**Notice of Allowability**

10/808,635

TEO, SIEW SIONG

**FIGURE 6**

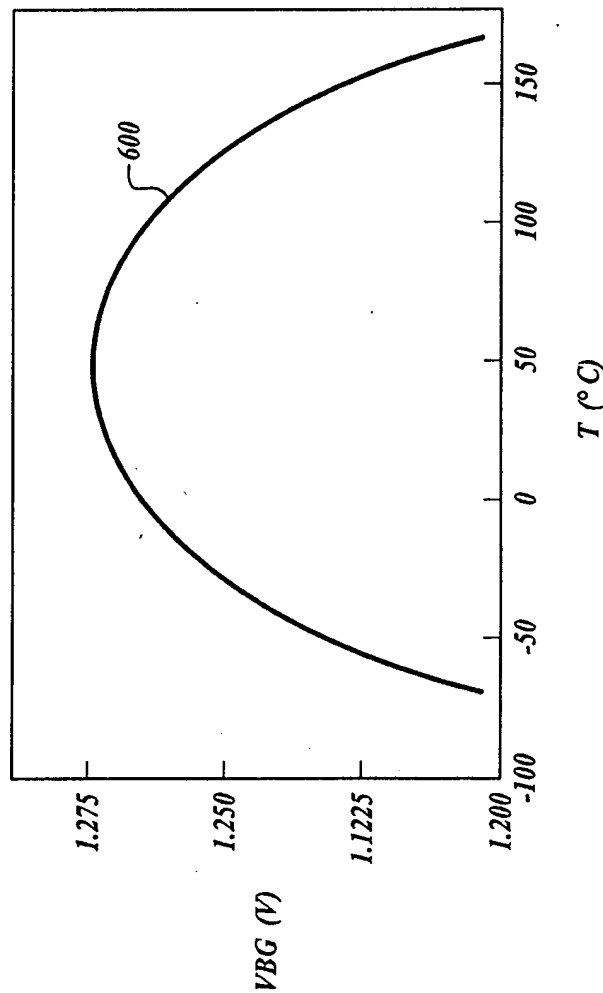
The Replacement Sheet for Fig. 6, and the amended paragraphs, and/or associated comments, overcame the objections to Figs. 5-6 as described on pages 2-3 of the previous Office Action. Therefore, those objections have been withdrawn.
